**13.2F - DAP Application – DAP/21/02078 -Da 21-67 | L300 Back Beach Road,
Onslow - Transient Workforce Accommodation (500 Persons)**

APPLICATION FOR PLANNING APPROVAL DA 21-67 | DAP/21/02078 | TRANSIENT WORKERS ACCOMMODATION - ONSLOW VILLAGE (500 PERSON) AT LOT 300 BACK BEACH ROAD, ONSLOW

Request For Information – Application for Planning Approval DA 21-67 / DAP 21-02078 – Transient Workers Accommodation – Onslow Village – Lot 300 Back Beach Onslow

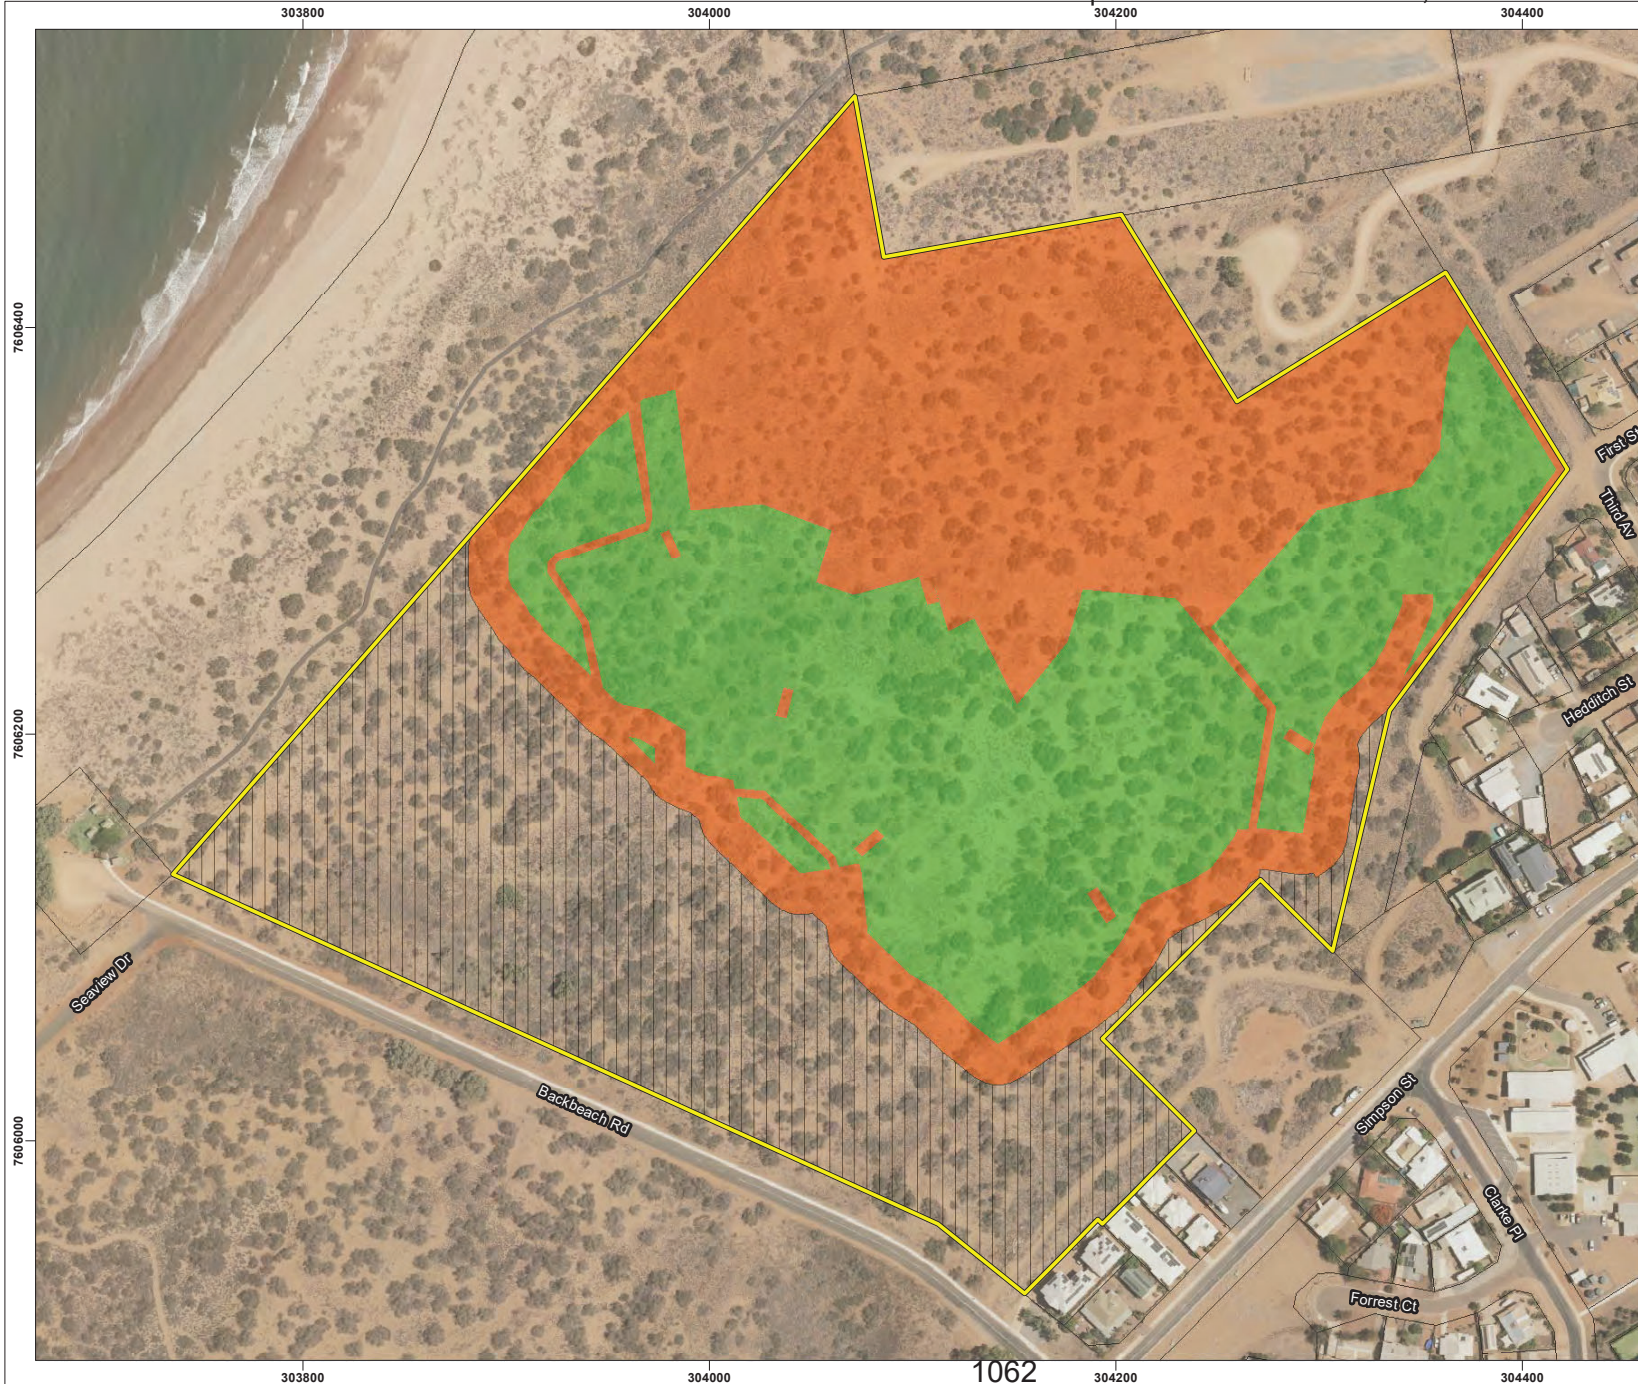
Please provide a Clearing Plan that illustrates the areas of native vegetation on the site that is proposed to be cleared as part of this development (this includes areas to be cleared for APZ).

Please provide a Clearing Plan that illustrates the areas of native vegetation on the site that is proposed to be cleared as part of this development (this includes areas to be cleared for APZ).

To assist the Shire of Ashburton with understanding the proposed clearing for this development application, we have prepared an indicative Clearing Plan for the assessment of the proposed development (Figure 1). The indicative Clearing Plan is based upon the draft NVCP application (which has yet to be formally lodged with the DWER). The indicative Clearing Plan identifies the following:

360 Environmental has prepared an indicative Clearing Plan applicable to the proposed development (refer above). This indicative Clearing Plan is inclusive of bushfire management requirements with respect to clearing requirements.
